H11718

DESCRIPTIVE REPORT

Registry No. H11718

General Locality Akutan Pass

Figure 10 H11718 Electronic Chart Comparison (US5AK6CM)

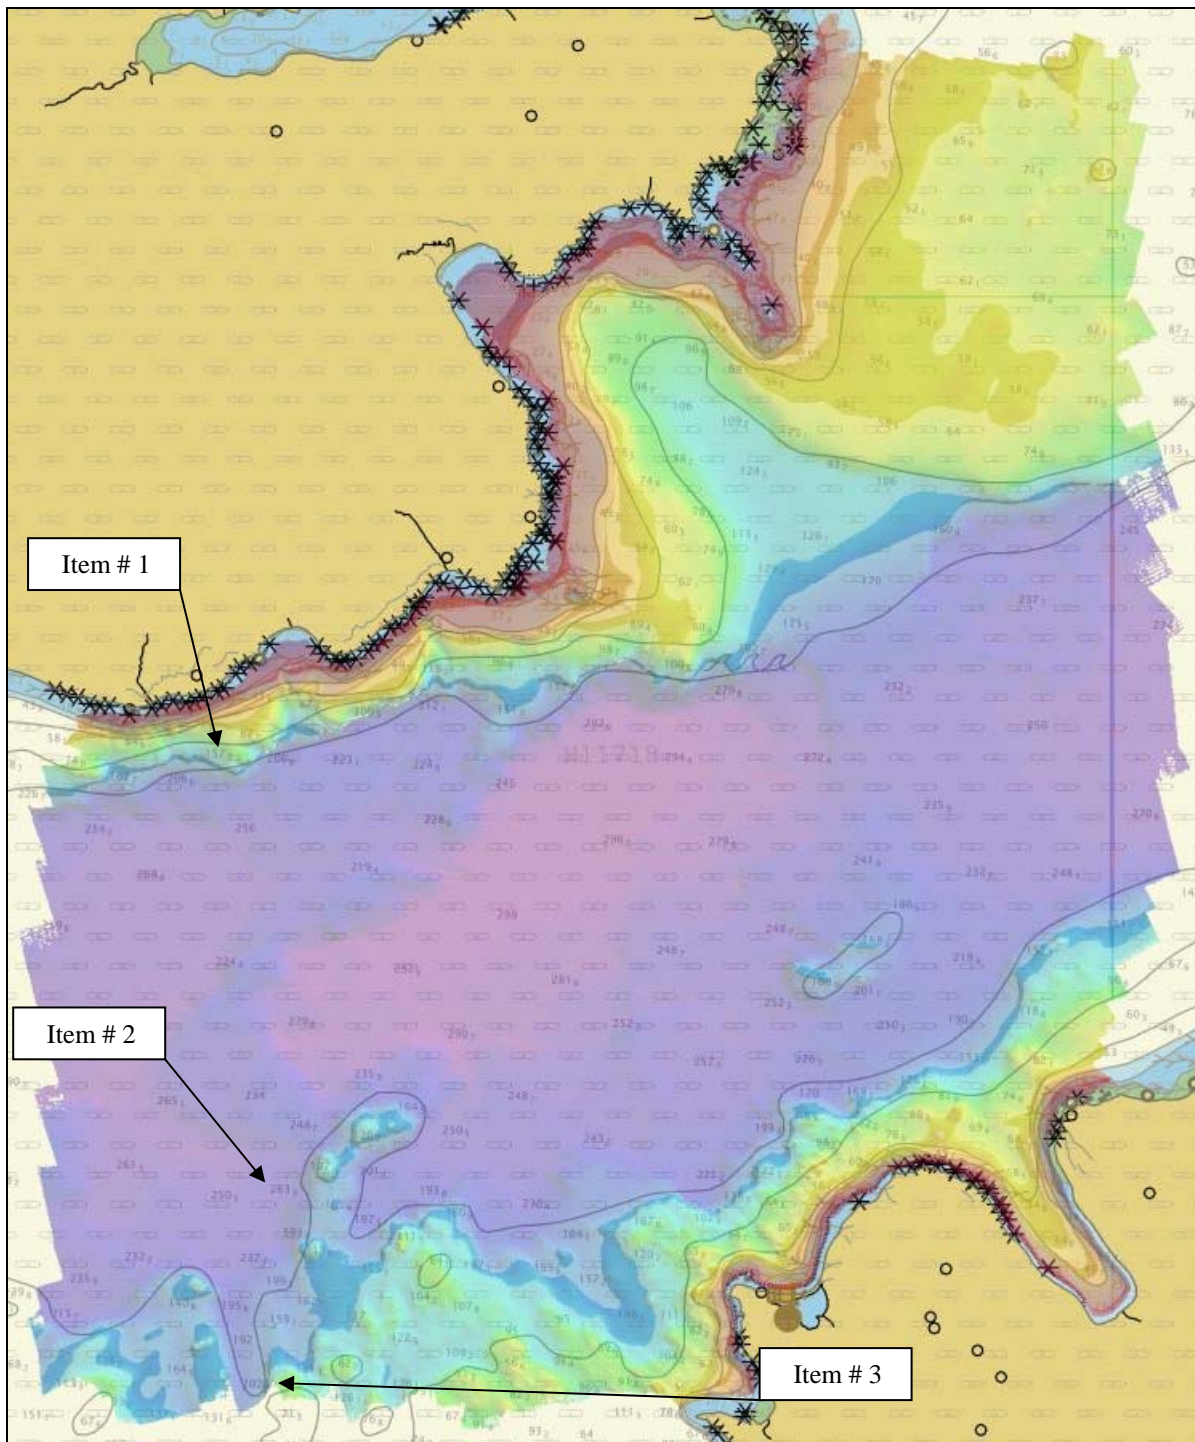
In general, the soundings from chart US5AK6CM coincide with the soundings from H11718 to within 5 to 15 meters; areas that do vary to any degree are as follows¹⁷:

- Item # 1: Hydrographic survey H11718 revealed a depth of 111 fathoms in the vicinity of a 157.2 fathom sounding on chart US5AK6CM located at 53°51'54" N, 166°16'34" W. This area was surveyed with 100% multibeam coverage. The shoaling is centered in the area depicted below.

¹⁷ All units on items 1-3 should read meters rather than fathoms.
